UNITED STATES PATENT AND TRADEMARK OFFICE

APPLICATION NO.	FILING DATE	FIRST NAMED INVENTOR	ATTORNEY DOCKET NO.	CONFIRMATION NO.
10/678,542	10/03/2003	Jude S. Sauer	INE-0001C	1340
23413	7590	05/07/2007		
CANTOR COLBURN, LLP 55 GRIFFIN ROAD SOUTH BLOOMFIELD, CT 06002			EXAMINER DAWSON, GLENN K	
			ART UNIT 3731	PAPER NUMBER
			MAIL DATE 05/07/2007	DELIVERY MODE PAPER

Office Action Summary

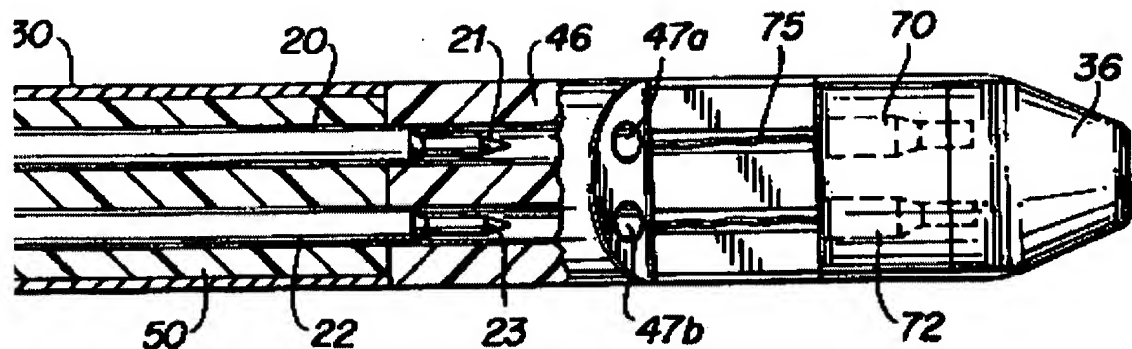
Sauer discloses a combination needle/ferrule where suture is attached to the ferrule. They are initially spaced from each other and the ferrule has a minimum internal dimension of a size to frictionally engage the maximum diameter of the tip portion of the needle. There is also a groove near the tip between the shaft of the needle and the tip of the needle.

Sauer does not specifically disclose that the maximum diameter of the needle tip is slightly larger than the ferrule. However, Sauer et al. discloses this limitation in col. 5 lines 60-63. It would have been obvious to have provided the needle tip to be slightly larger than the inner dimension of the ferrule in order to provide a reliable friction fit between the needle tip and the ferrule. As for the proximal tapering of the groove towards the shaft, the applicant did not provide any criticality for this limitation, did not state that it solved any particular problem or was for any particular purpose, and the examiner contends that the prior art groove shape would have performed equally as well, making this limitation nothing more than an obvious design choice.
